Subject: Incidental Take Permit for 2081-2017-068-03 Caltrans Bridge Seismic Retrofit Mokelumne (03-SAC-05-3F090) Project, San Joaquin and Sacramento County, Amendment No. 1

AMENDMENT NO. 1
(A Minor Amendment)

California Endangered Species Act
Incidental Take Permit No. 2081-2017-068-03
California Department of Transportation, District 3
Caltrans Bridge Seismic Retrofit Mokelumne (03-SAC-05-3F090) Project,
San Joaquin/Sacramento County

**Estimated Impacts to
Mokelumne River from Trestle Piles
Caltrans Bridge Retrofit Project 03-3F090
Mokelumne River Bridge I-5
at the Sacramento/San Joaquin County Line**

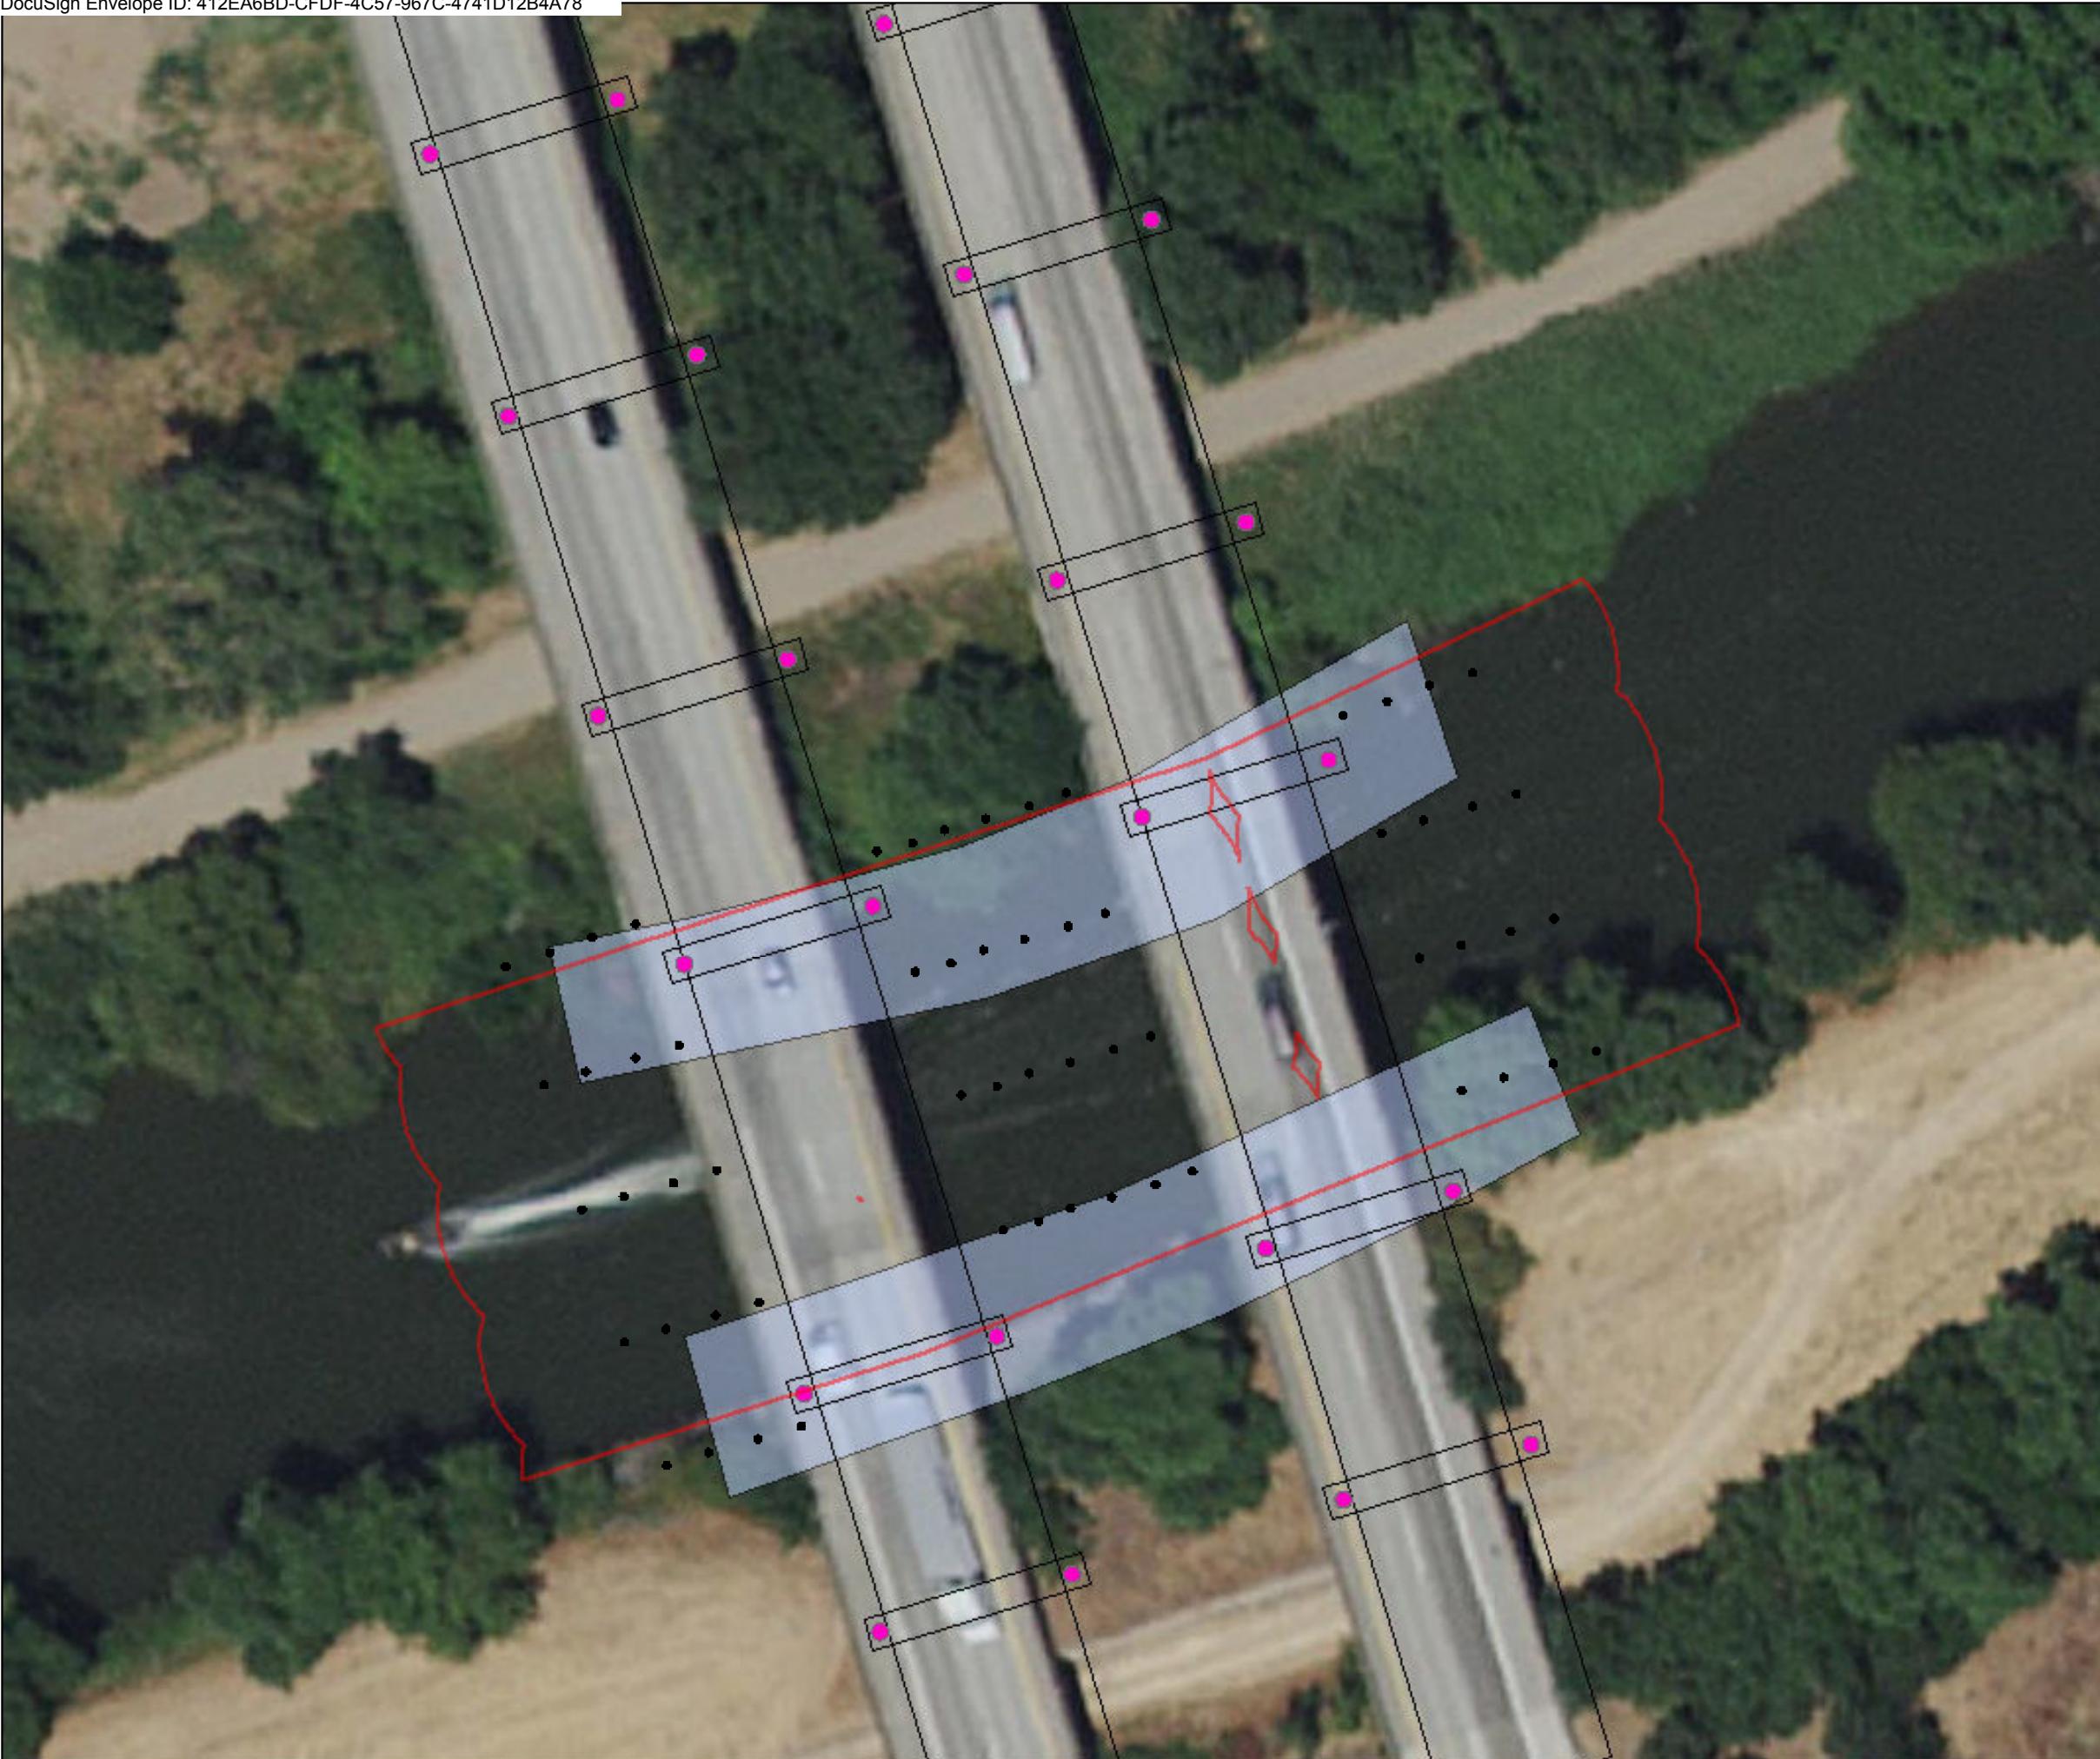
be kept below the interim thresholds, 206 decibels (dB) peak Sound Pressure Level (SPL) and 187 dB cumulative Sound Exposure Level (SEL). The Project has specified a 0.5-acre peak injury zone for the 206 dB SPL and a 5.5-acre area for the cumulative SEL injury zone as specified in Figure 7 **and 9**. If the 206 dB SPL or 187 cumulative SEL threshold injury zones are exceeded for impact pile driving the Permittee shall stop all impact pile driving activities and not continue until CDFW has been consulted. Any exceedance in the threshold distances (Figure 7 **and 9**) shall require an Amendment to this ITP. The Permittee shall monitor sound levels as specified in Condition of Approval 8.6, during impact pile driving activities occurring within the river channel, as well as for piles within a reasonable distance of the water on dry land (within 200 feet of the edge of water in the active channel) where sound levels may be injurious to Covered Species.

The Project is also expected to cause 0.5 acres of impact in a peak injury zone for injurious sound levels and 5.5 acres of injury for a cumulative sound exposure level zone (See Figure 7, **9 and 10**).

- Trestle piles (24")
- 0.004 acre
temporary impact
(proposed plan)
- Hydroacoustic
impact - 10 m
buffer - 0.752
acres
- Proposed CISS
Piles
- Mokelumne River
Bridges
- Temporary Pad -
0.36 acre
temporary impact
(previous plan)

Mokelumne River Trestle Plan Design Set

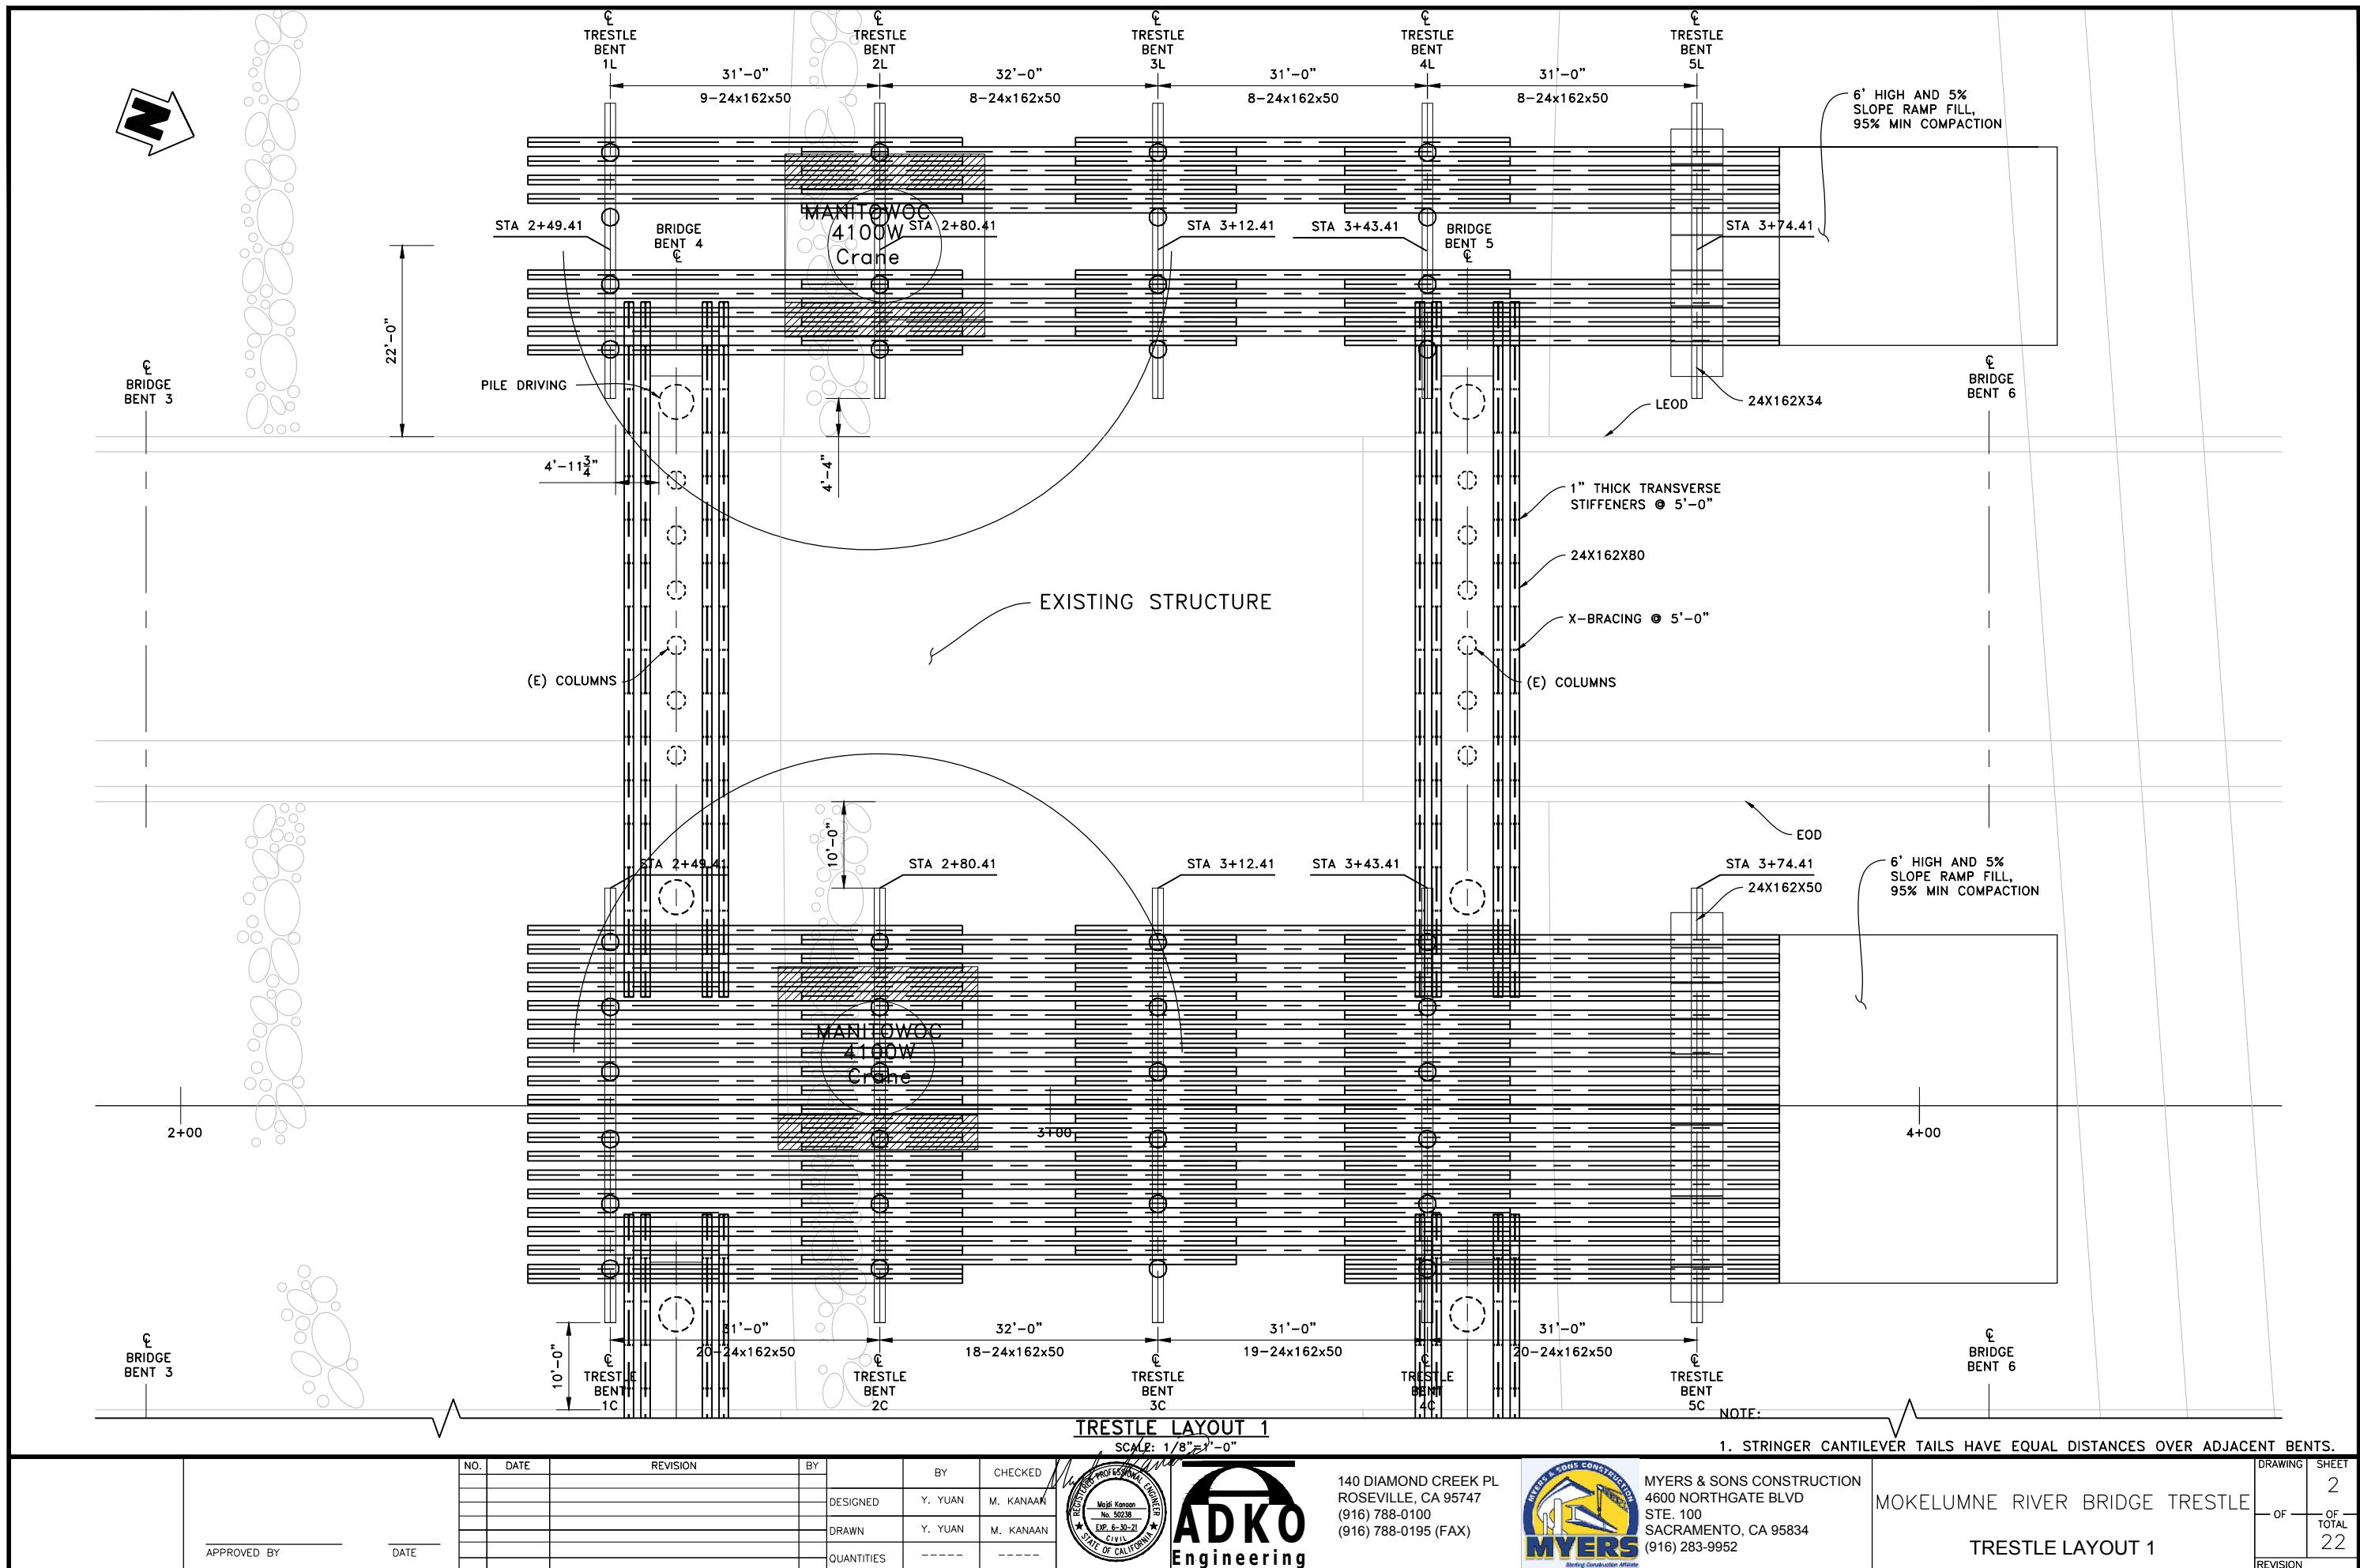
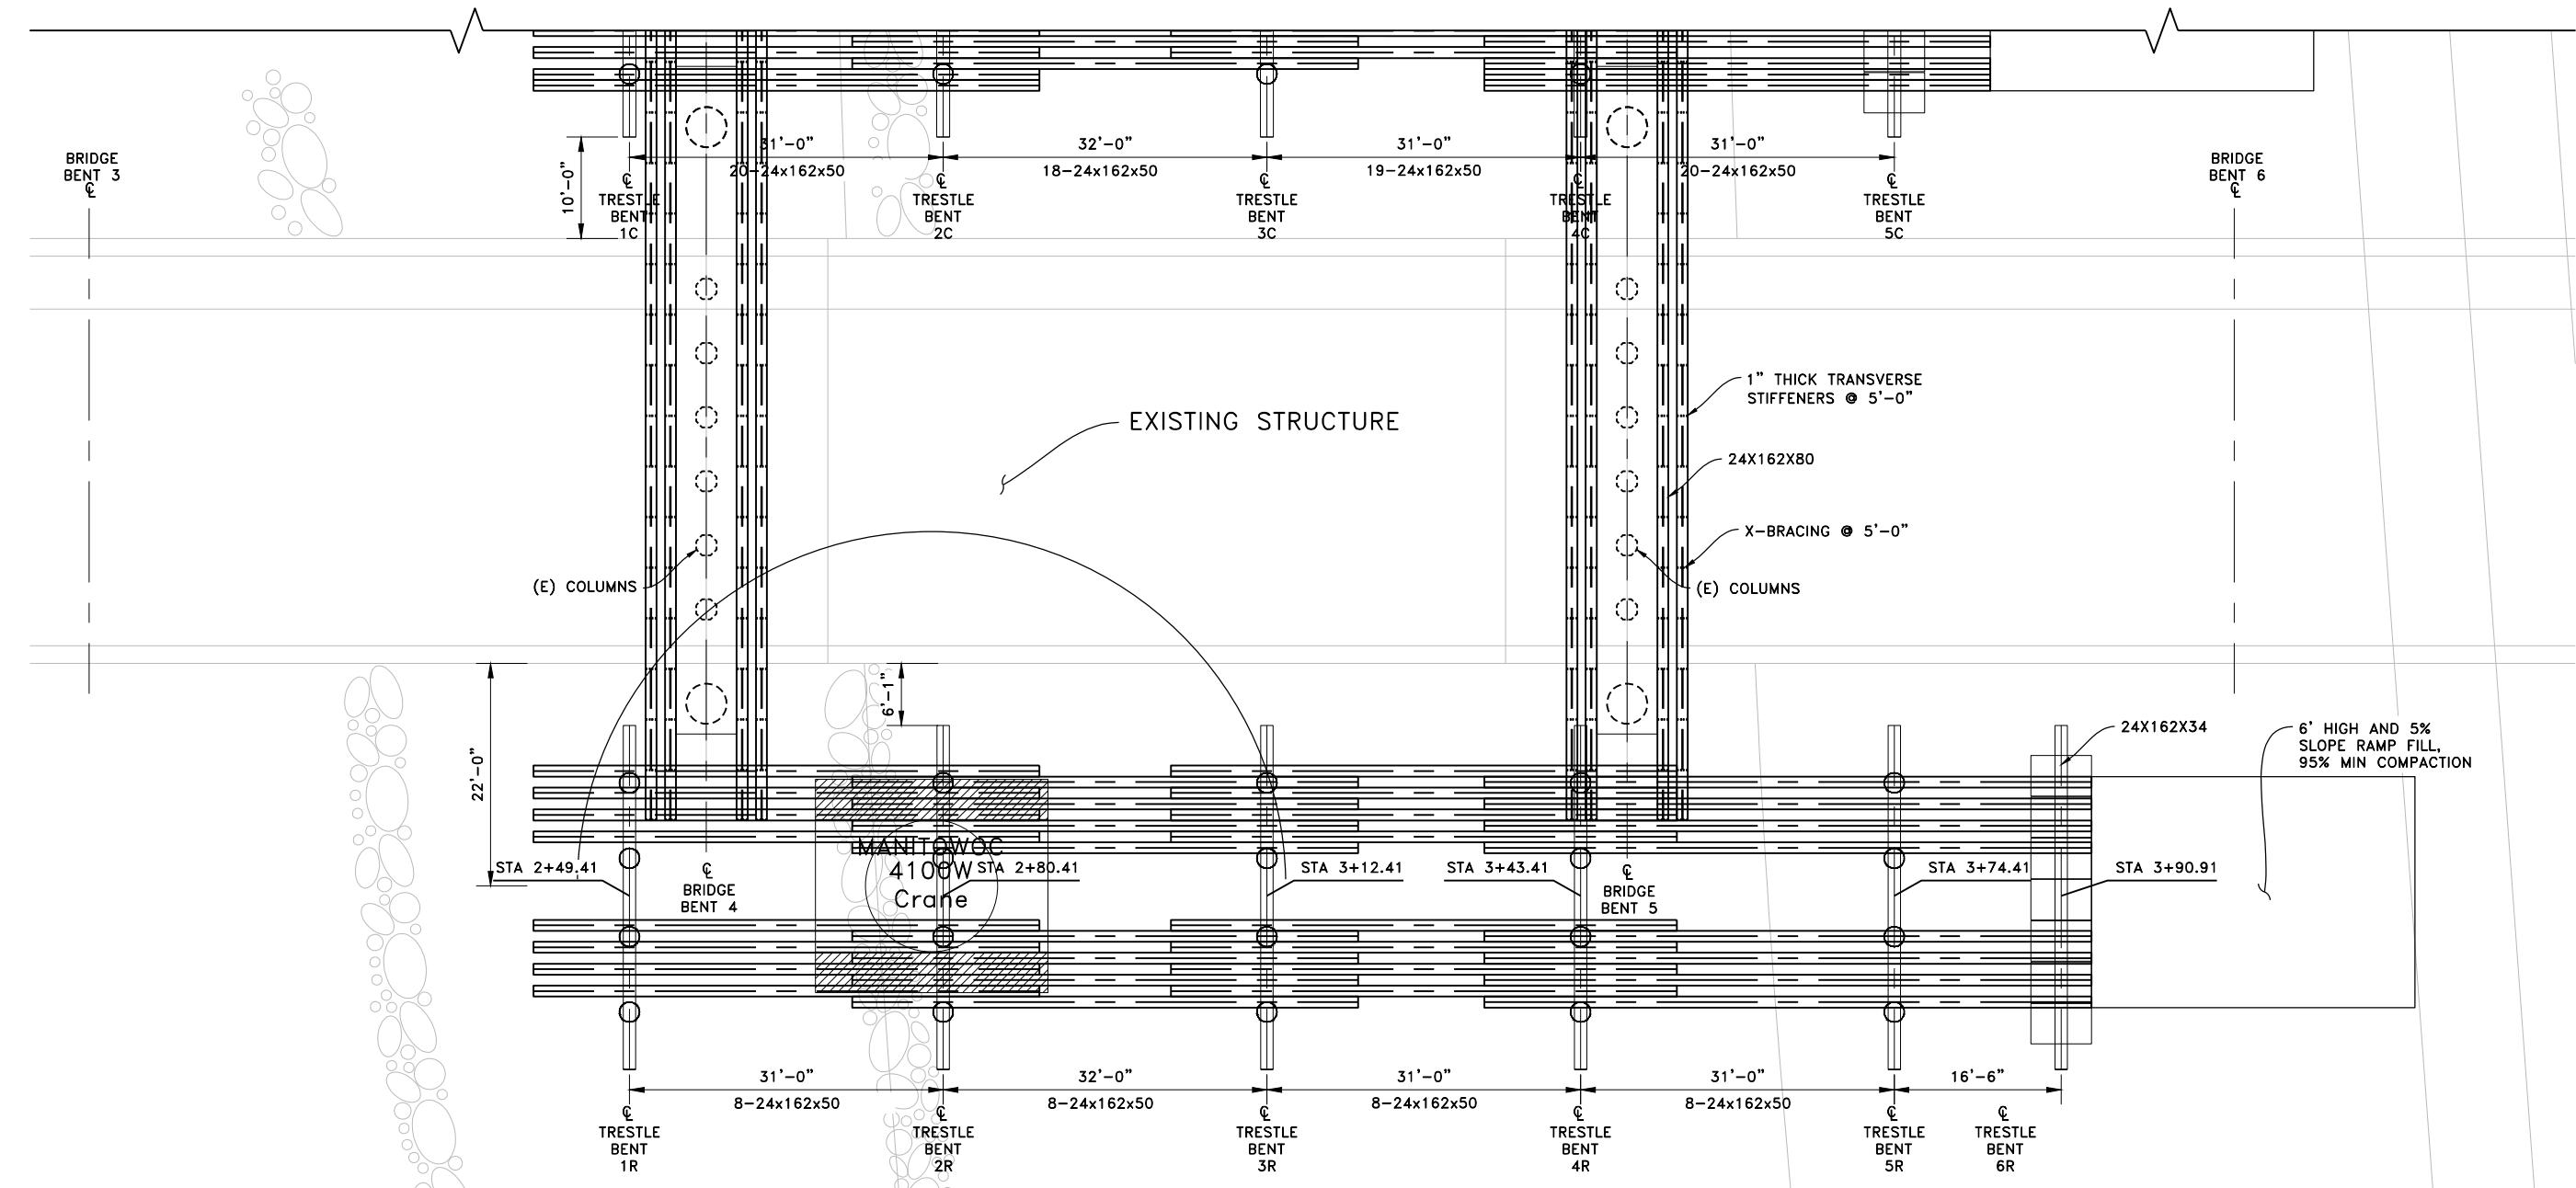
Construction equipment access and operation at Bents 4 and 5 will construct three temporary trestles. One on the east side, one down the middle and one on the west side of the bridge (See Figure 11). A total of sixty 24-inch pipe piles will be installed by vibratory means, with the exception of two piles which will be impact driven in order to verify bearing capacity. The two trestle piles that will be impact driven will take a total of 76 total strikes and will receive a sound attenuation system and hydro-acoustic monitoring (See Figures 9 and 10). The installation of the trestles will begin on July 15. The in-water temporary impacts from installation of the 60 piles is 0.004 acres. The trestle will be left in place for two seasons and all 24-inch piles will be completely removed by vibratory means with the use of crane and vibratory hammer upon completion of the Project.
